REMARKS

Claims 1-17 are pending in this case. Claims 1, 2 and 6-8 have been rejected. Claims 3 - 5 and 9 have been objected to. Claims 10 - 17 have been allowed. Claims 1, 3 and 9 have been amended to more particularly point out the subject matter claimed by the Applicant as his invention. No new matter has been added.

Figure 1

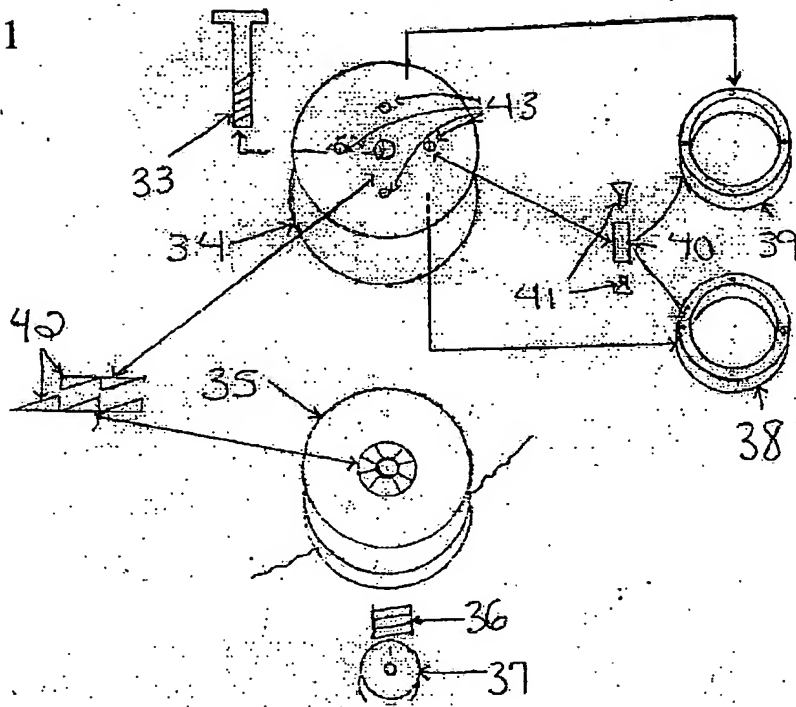
The Examiner has objected to the drawings. Figure 1 has been amended to more clearly show the location of the bottom ring 38 as being underneath the top surface of the spool housing 34 and top ring 39 being above the top surface of the spool housing 34.

Drawing Correction  
Approved  
107  
7/9/04
